Application No; A-24:136

We are writing with respect to the minor variance application number A-24:136.

Project Address:
**35 CITATION CRES
 ANCASTER, ON
 L9K 1H8**

1 SITE PLAN
 SCALE 1:200

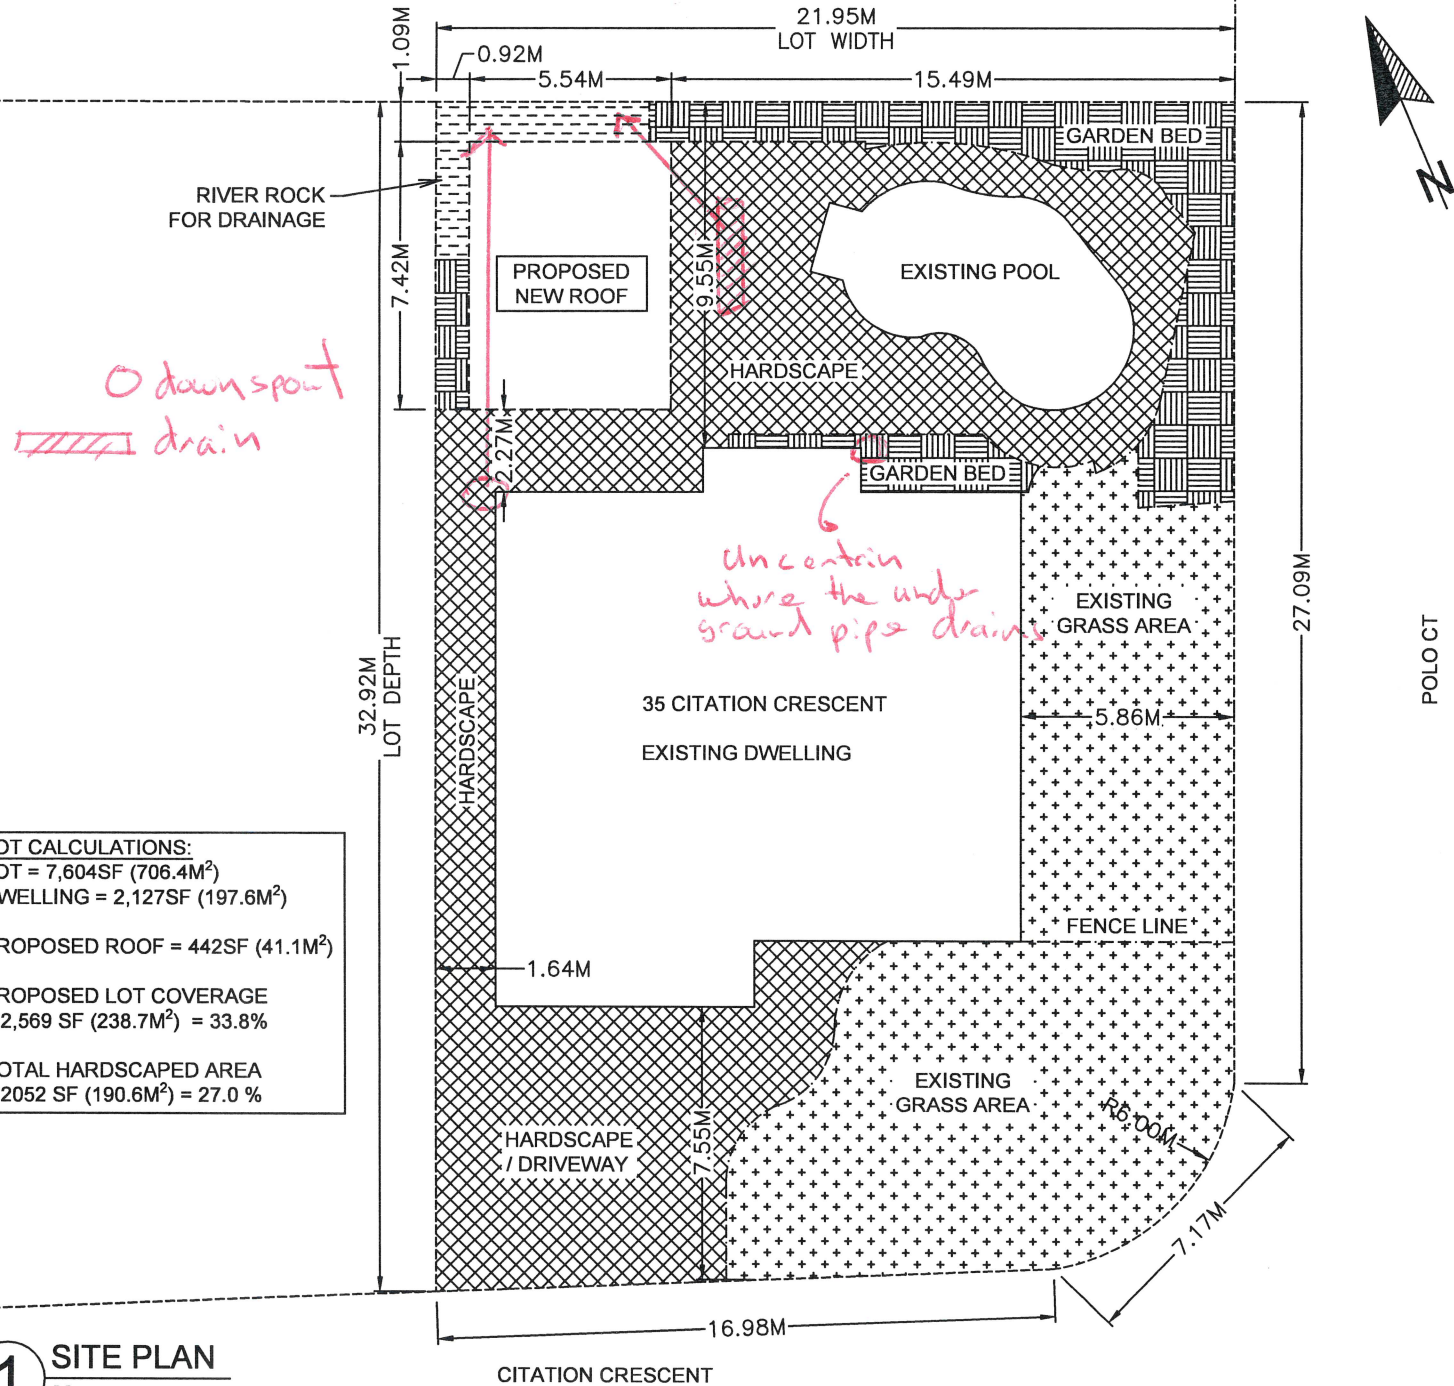
The applicant has eliminated all greenspace to hardscaped surfaces in the rear yard to accommodate the construction of this secondary structure. The hardscape surface runs from the rear of the house up the area where the pebble stones and garden bed as can be seen in the attached plan. The height of the hardscape is approximately 18 to 20 inches higher than the original grade between the property line.

In addition to the height of the structure we have concerns with the revised drainage of the subject property. They have redirected two rear downspouts and installed a drain which all run under the hardscape to the pebble stone and garden bed for drainage, as we have shown in the red-lined attached document. Given the amount of water that comes from the downspouts we have concerns that there may be flooding on the joint property line. In fact, the applicant requested, via the City of Hamilton, that we divert our sump pump outlet, which we have done, away from this exact area. An additional concern is that the elimination of greenspace to hardscaped surface will result in accelerated rainfall drainage from their property to ours and possibly into the side of our house.

4 Pdo Court Side Yard

0 downspout
drain

in center
where the under
ground pipe drains

1 ROOF FLOOR PLAN
 SCALE 1:50

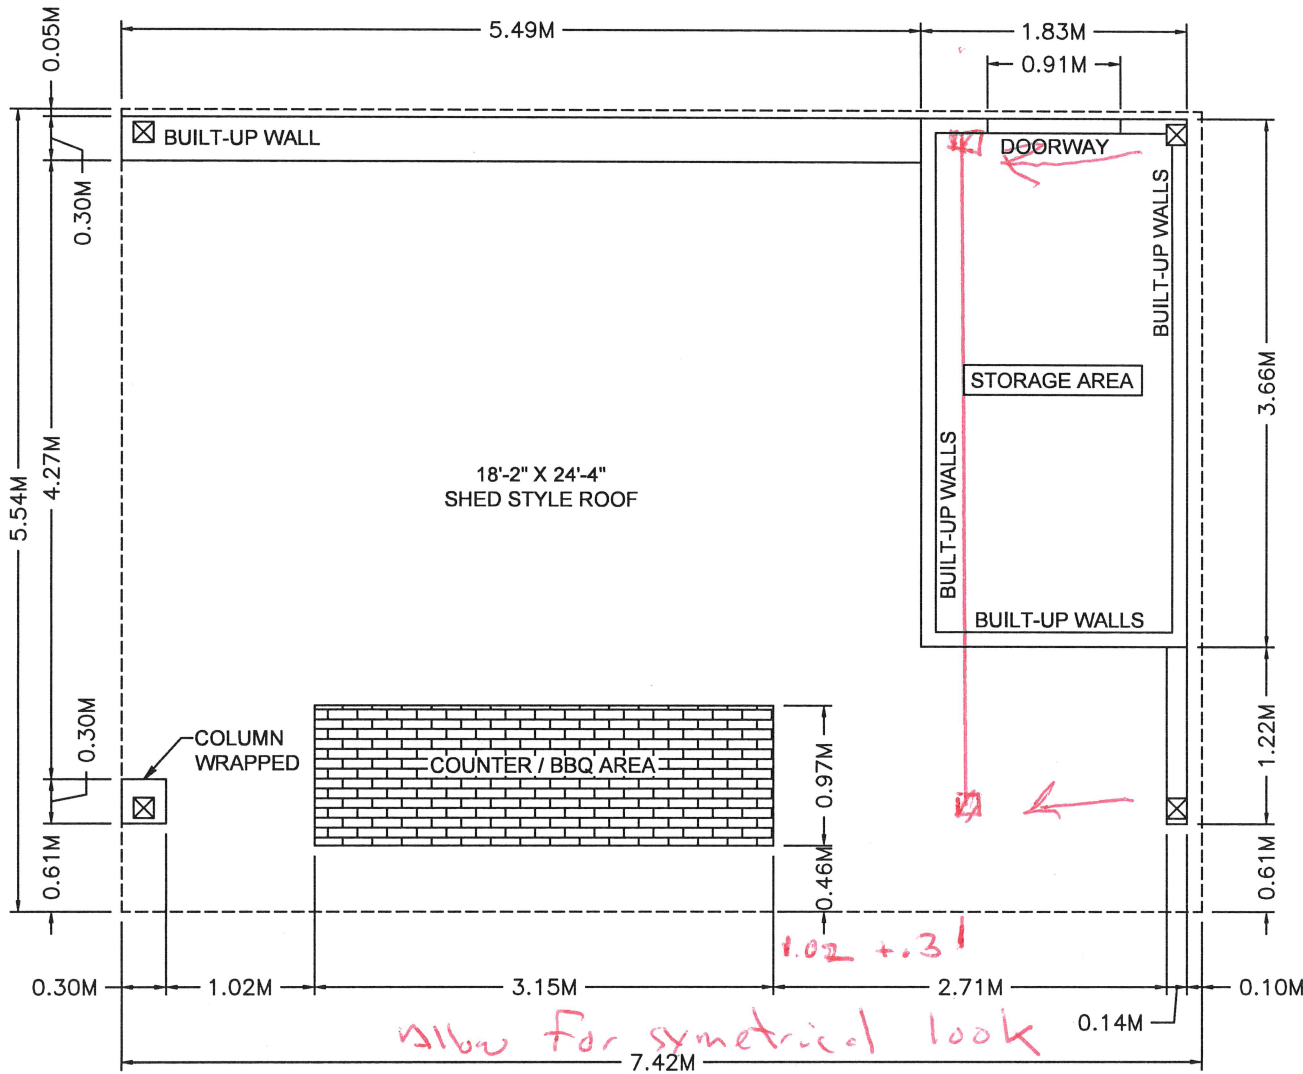
Finally, we are very concerned about the overall proposed structure. We understand that the proposed structure of 40m² is almost 3.5 times greater than what is permitted in the City's by-law. The subject property's rear yard abuts our property's side yard which is used for ingress and regress to our back yard. The proposed structure is much too large and far too close to our joint property line and to our home. The applicant already has a structure for storage so we feel that including additional storage as part of the overall structure should be reconsidered. We are concerned over views and site lines and blocking of natural light and resulting shadows. The elimination of the storage area will reduce the roof size by approximately 10m² and provide for a set back from the rear yard and our side yard of approximately 2.92m and should not have an adverse effect to the primary purpose of this structure. The attached red-lined drawing allows for a symmetrical measurements on each side of the proposed Counter/BBQ Area.

1.02 + .31
also for symmetrical look
